**Interim Record of Decision  
Remedial Alternative Selection  
for the Old Radioactive Waste  
Burial Ground (643-E) (U)**

**WSRC-RP-96-102**

The public comment period for the Interim Action Proposed Plan (IAPP) for the Old Radioactive Waste Burial Ground (ORWBG) began on February 2, 1996 and ended on March 2, 1996. A public meeting was held on February 27, 1996. Six sets of comments were received on this proposed interim action. Specific comments and responses are found below. The comments are italicized and the responses are bolded.

Figure 2. Location of the Old Radioactive Waste Burial Ground.

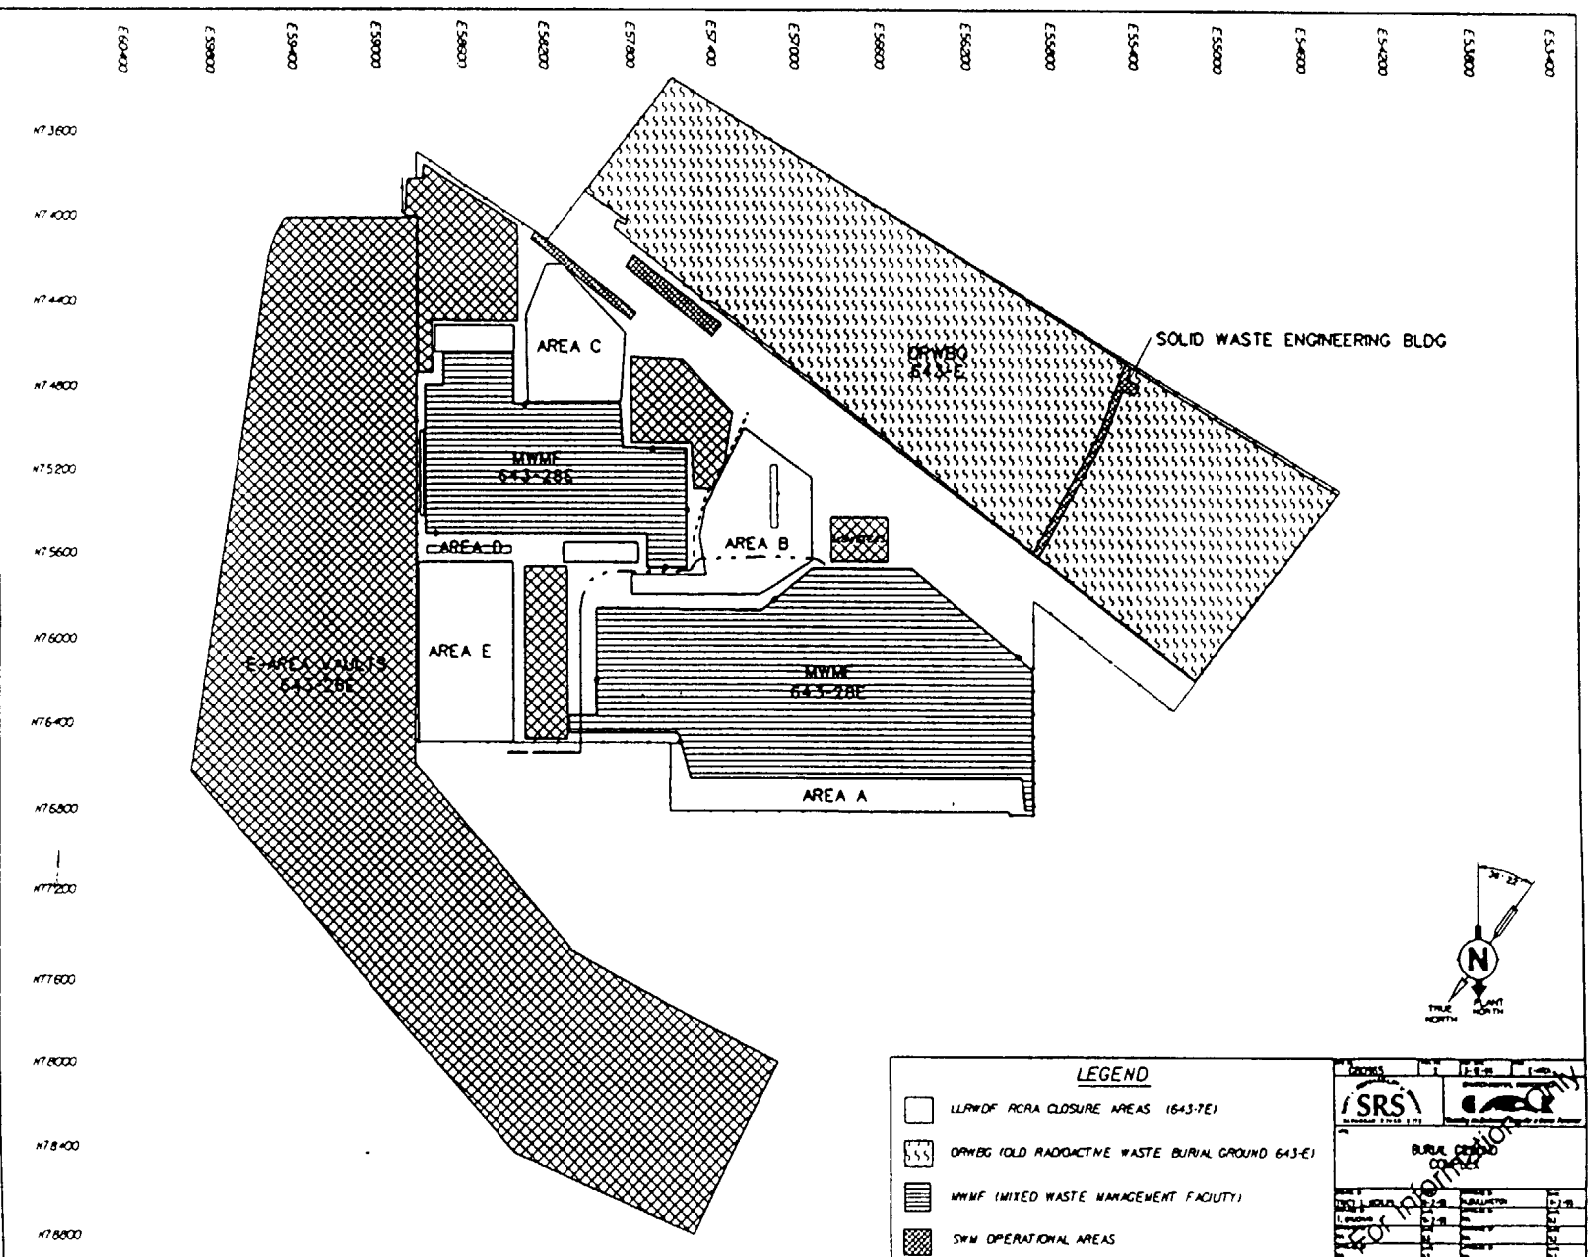
- S-2) Figure 2 is illegible. It needs subtitles to show where the parts that are discussed in Section I are located. The Legend is of no help - all areas look alike.*

**Figure 2 was revised to ensure that the reader can see where the parts that are discussed in Section I are located. The Legend was also revised to make it easier to understand.**
